## NOTICE OF DECISION

FILES: SD-02-16

TYPE OF APPLICATION: Land Division - Tentative Plat Review to create a six-lot subdivision in two phases; with five lots proposed in Phase 1.

ADDRESS/LOCATION: 2749 NW CROCKER LN, ALBANY, OR 97321 / 1.39 acre site at the SE corner of the intersection at Crocker Lane and Arroyo Ridge Drive

**TENTATIVE SUBDIVISION PLAT**

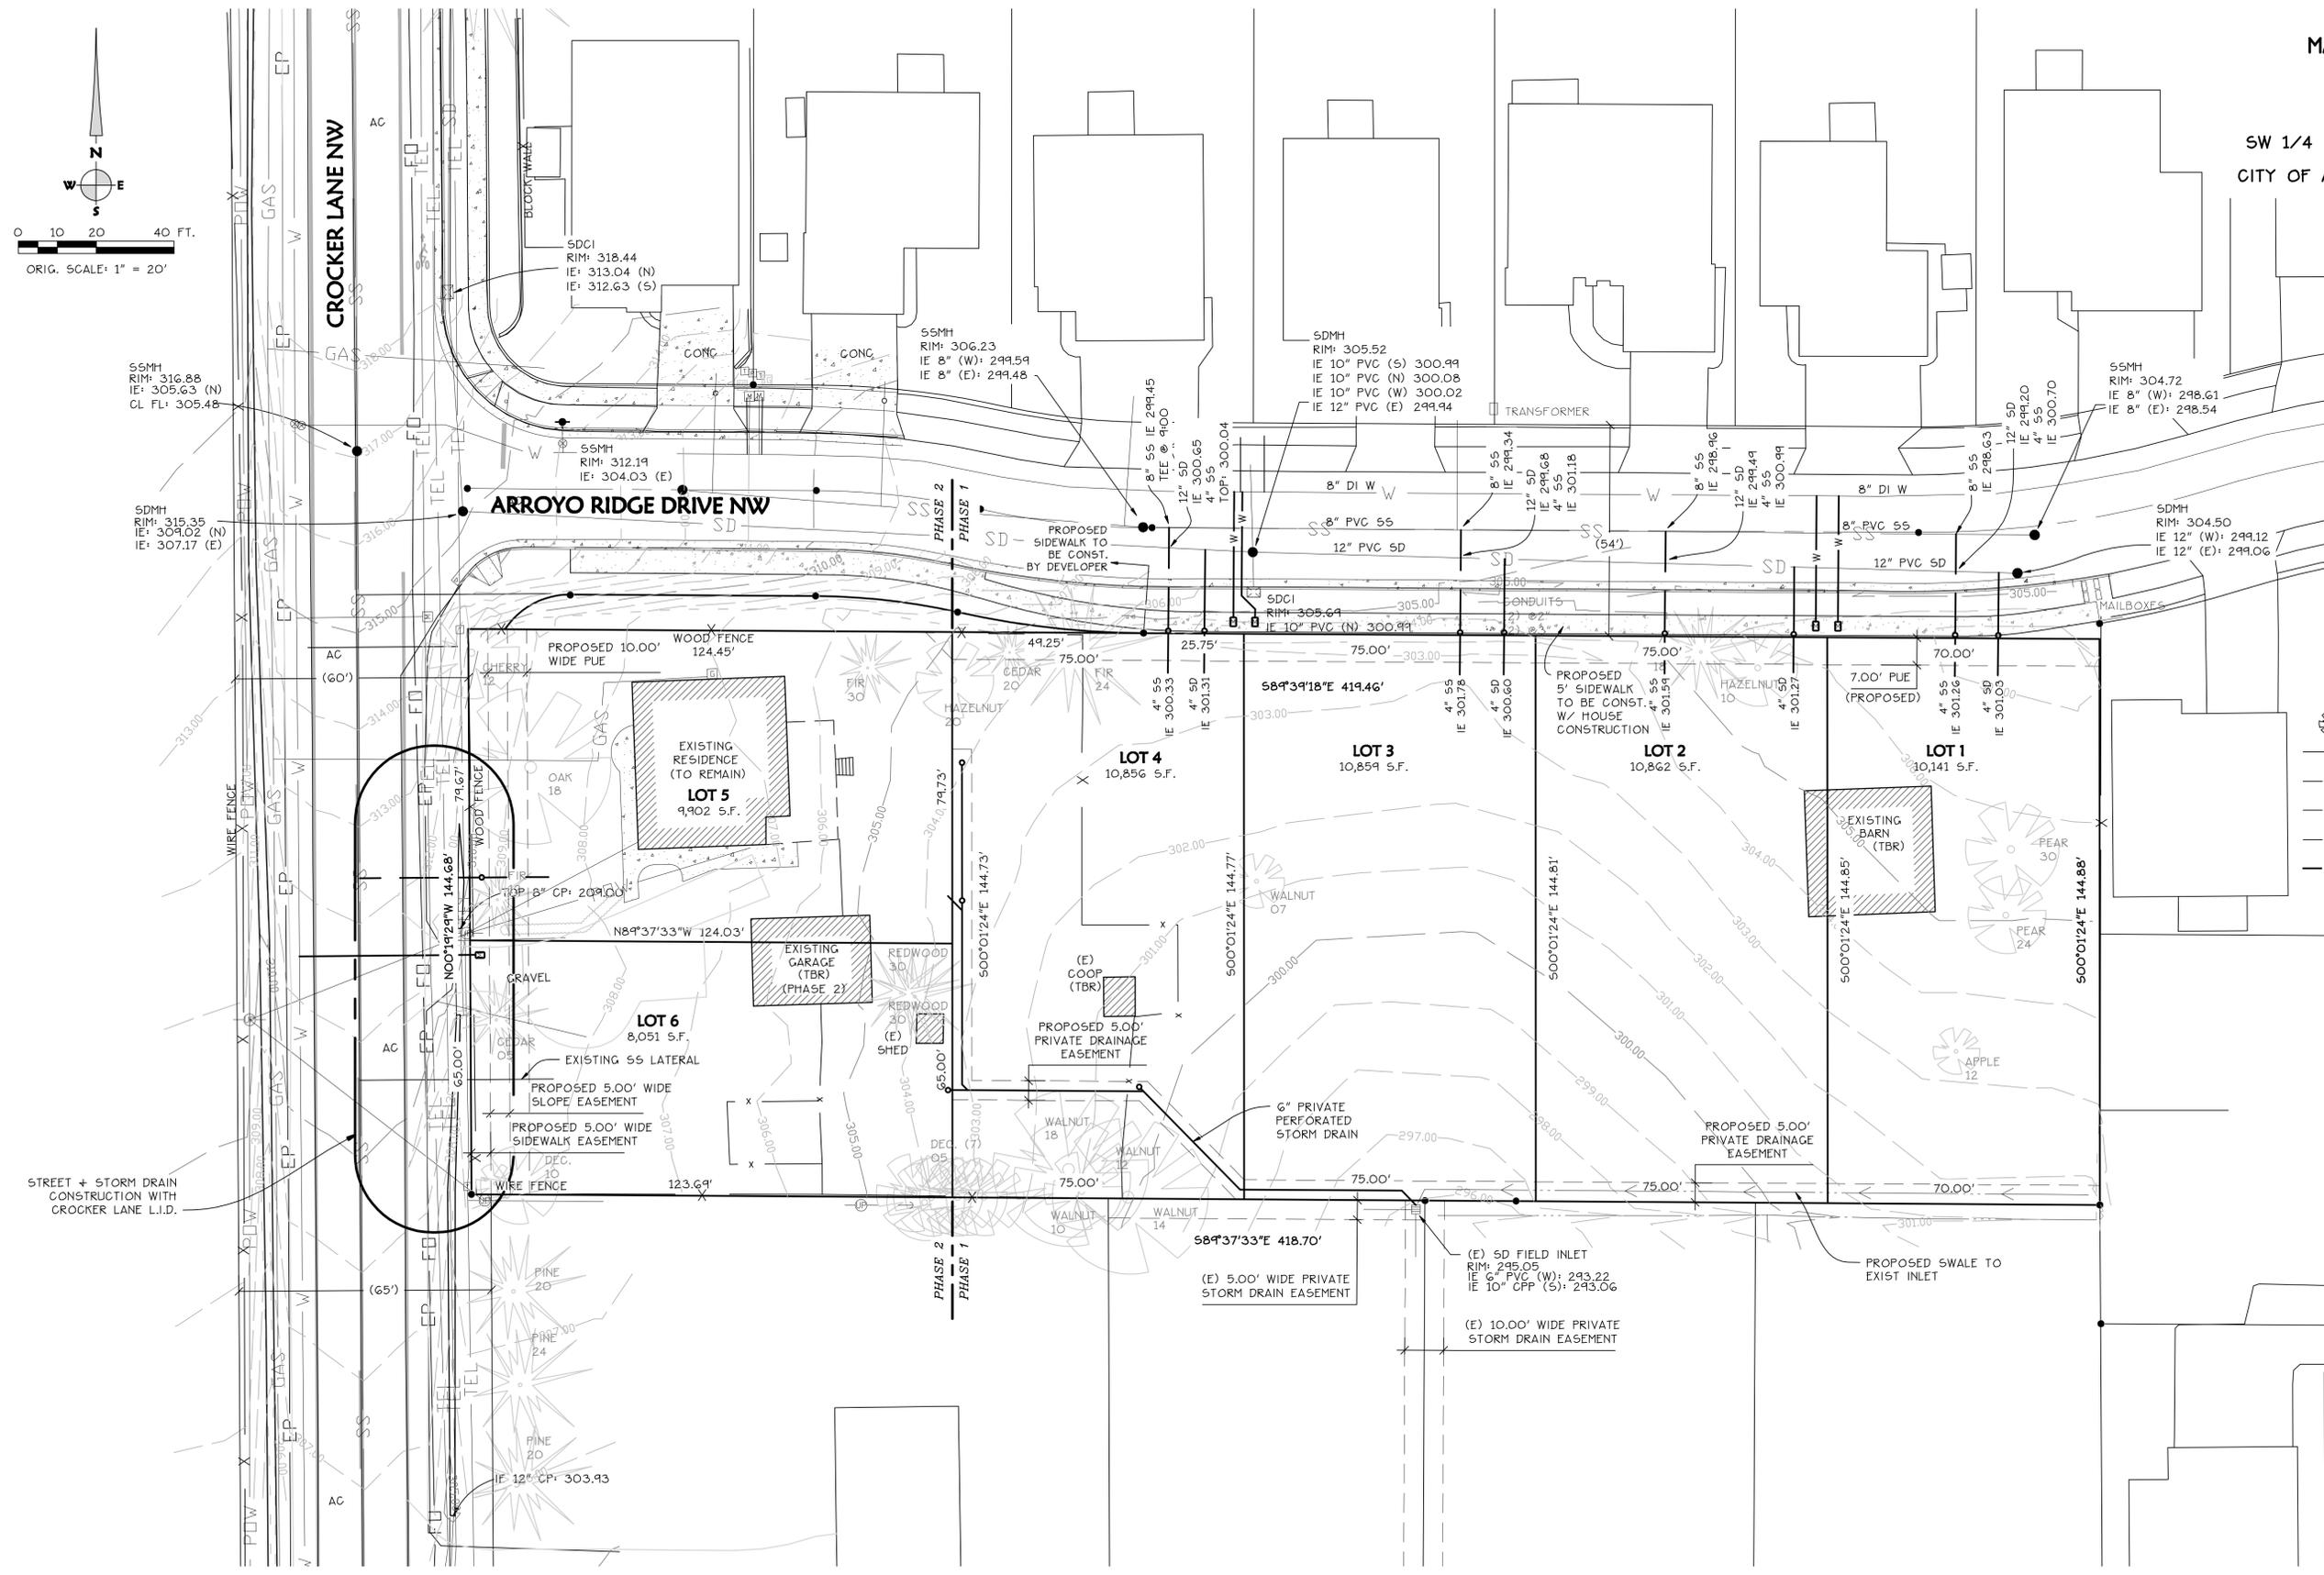
- 1.1 The detached garage located over the shared lot line proposed for Lot 5 and Lot 6 shall be removed prior to Phase 2 final plat approval. All other accessory structures within the subdivision site shall be removed prior to Phase 1 final plat approval. Alternatively, the applicant may obtain approval to relocate the buildings in accordance with applicable development code standards.

- 3.1 On the final plat for Phase 1, the applicant shall dedicate a five-foot wide public sidewalk easement along the site's frontage on Crocker Lane.
- 3.2 On the final plat for Phase 1, the application shall dedicate a 15-foot public slope easement along the site's frontage on Crocker Lane.
- 3.3 Prior to final plat approval for Phase 1, the applicant shall install, or financially assure construction of, the public sidewalk to city standards on the south side of Arroyo Ridge Drive along the length of Lot 5.
- 3.4 The final plat for Phase 2 shall show a 24-foot wide shared access easement to Crocker Lane along the common property line between Lot 5 and Lot 6 for the benefit of both parcels. The easement shall extend a minimum of 20 feet into those lots and may be dedicated on the final plat or by separate document.

- 4.1 Prior to Phase 1 final plat approval, the applicant shall obtain a storm water quality permit from the City's Public Works Department for the entire subdivision.
